RE: 8300 Calle Nortena NW
Grading Plan
Stamp Date: 4/3/17
Hydrology File: C11D003

RE: 8300 Calle Nortena NW
Grading Plan
Stamp Date: 2/7/17
Hydrology File: C11D003

ENGINEER'S SEAL DAVID SOULE NEW MEXICO REGISTERED PROFESSIONAL ENGINEER 14522 4/3/17	8300 CALLE NORTENA FECTEAU RESIDENCE GRADING AND DRAINAGE PLAN  <i>Rio Grande Engineering</i> 1606 CENTRAL AVENUE SE SUITE 201 ALBUQUERQUE, NM 87106 (505) 872-0999	DRAWN BY WCWJ DATE 3-06-17 21715-LAYOUT-3-06-17
		SHEET # — JOB # 21715

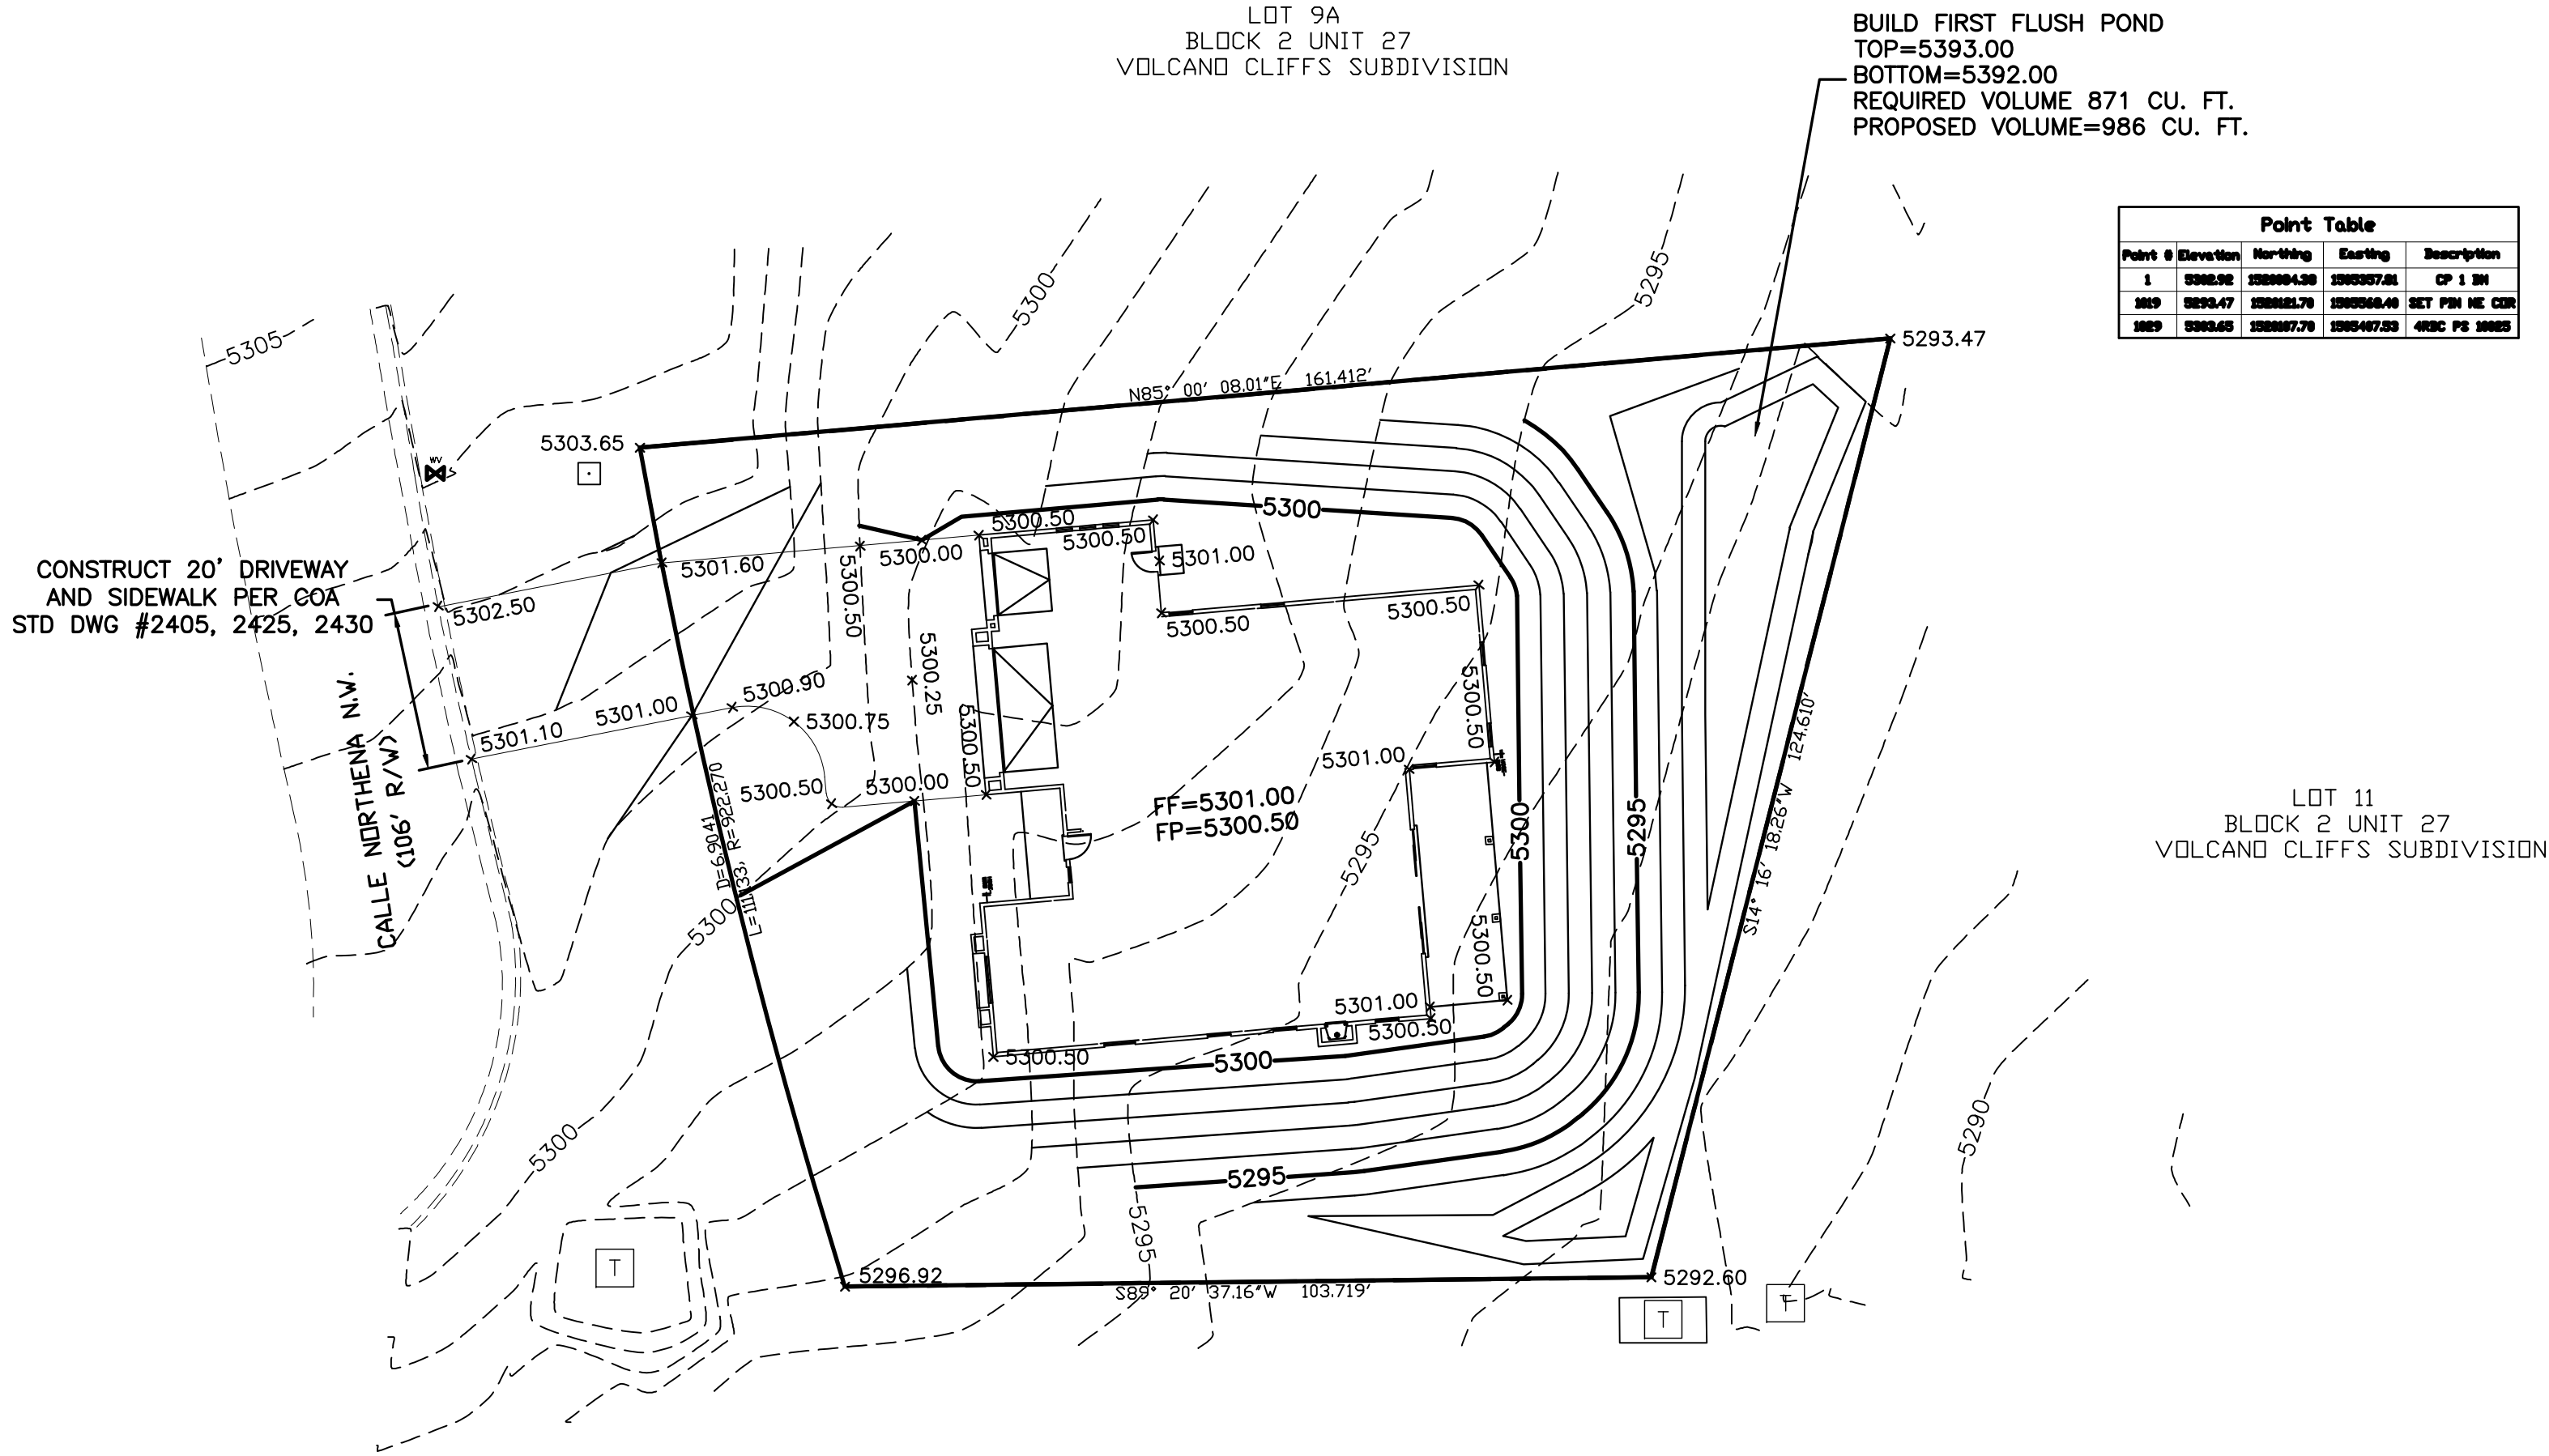
Based upon the information provided in your submittal received 3/7/2017, the Grading Plan **is not** approved for Building Permit. The following comments need to be addressed for approval of the above referenced project:

1. It appears that you calculated required volume for capturing the first ½ inch (detention) is low. It should be 0.02 ac-ft or 871 CF.
WE HAVE INCREASED BUT I CALCULATE $15199 \times (.5) / 12 = 633$
2. The proposed grading appears to actually separate the site into two separate drainage basins. The north half drains to the proposed pond. The south half drains to the southeast corner of the site. The south half of the site's drainage is not captured by a pond and just directly flows off site. You need to create a pond to capture the runoff.
WE HAVE MODIFIED THE POND TO CAPTURE ALL BASIN

ONSITE Conditions
FIRST FLUSH WATER QUALITY VOLUME
REQUIRED
(CF)
WATER QUALITY
CAPTURE OF 1ST 1/2 INCH
146
633
PROVIDED
(CF)
968
968

This site is within the NW mesa are of Albuquerque. The site is to maintain existing drainage patterns
Due to the existing elevations, discharge to the street is not practical. Due to street the site is not impacted by upland flows
Due to its location directly upstream of public open space we propose ponding the first 1/2" and allowing the excess to discharge
the historic outfall
